Standard Development Timeline

Description of Current Draft

This is the ~~first~~second draft of the proposed standard being posted for a formal 45-day comment period and additional ballot.

1. **Title:** Verification of Real and Reactive Power Capability for BES Facilities
2. **Number:** MOD-025-3
3. **Purpose:** To ensure that accurate information on Bulk Electric System (BES) Facility Real and Reactive Power capability is available for planning models used to assess BES reliability.

Section I. Provide simplified one-line diagram ~~of~~**representing** the applicable Facility showing plant auxiliary Load connections.

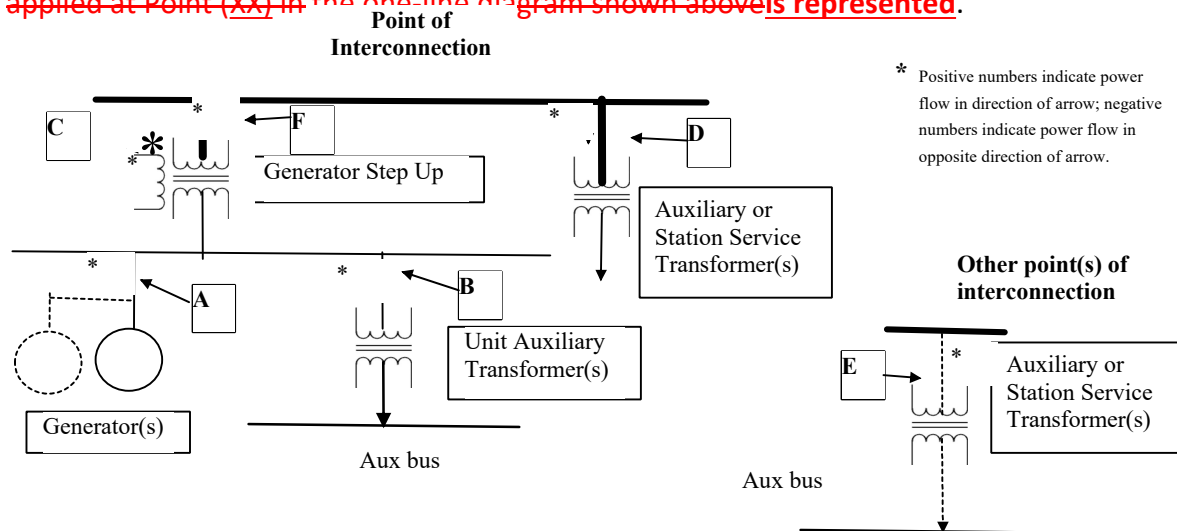
Identify on the one-line diagram where the ~~The~~ composite capability curve ~~provided below is applied at Point (XX) in the one-line diagram shown above~~ **is represented.**
